ASUS		Title : E30 TOUCH PAD	
ASUSTeK COMPUTER INC. NB1		Engineer:	
Size A	Project Name UX30 TOUCH PAD BD		Rev 1.2
Date: Wednesday, May 06, 2009	Sheet 1 of 2

UX30 TOUCH PAD BD R1.1 Change List

Title : HISTORY

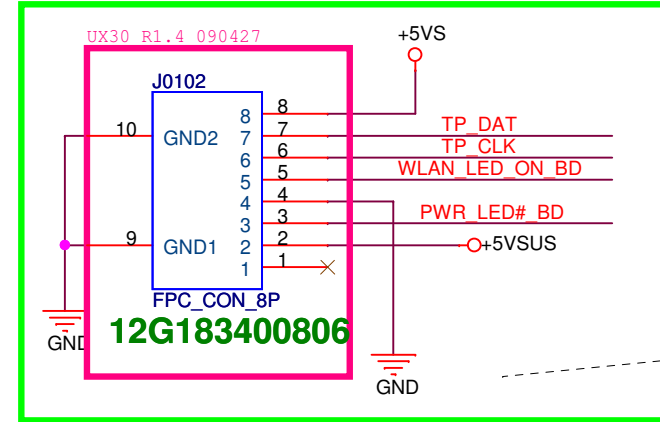
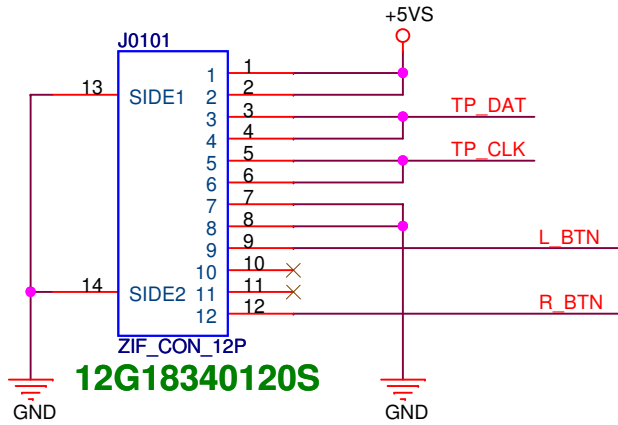
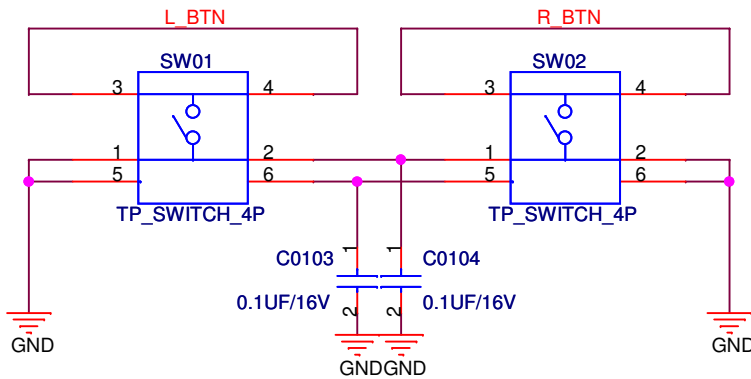
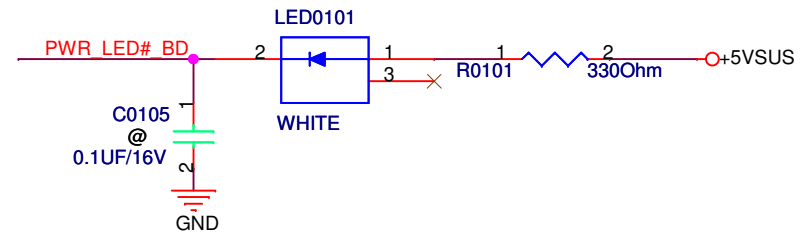
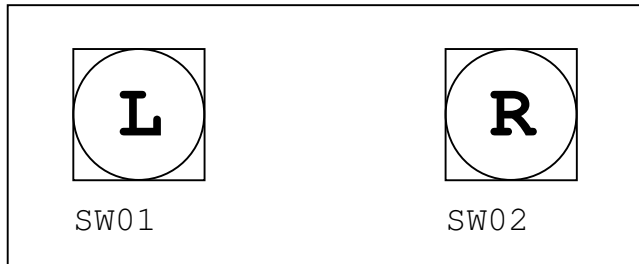
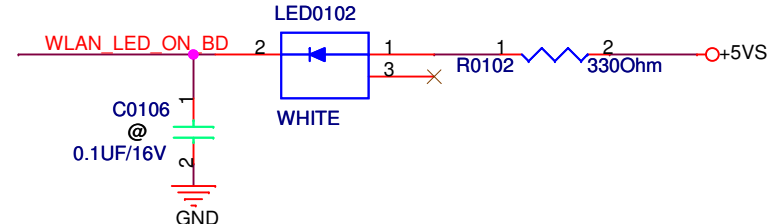
- 1. Change J0102 from 6 pin to 8 pin and change pin define for PM spec change
- 2. Add LED0101 and R0101 for PM spec change
- 3. Add LED0102 and R0102 for PM spec change
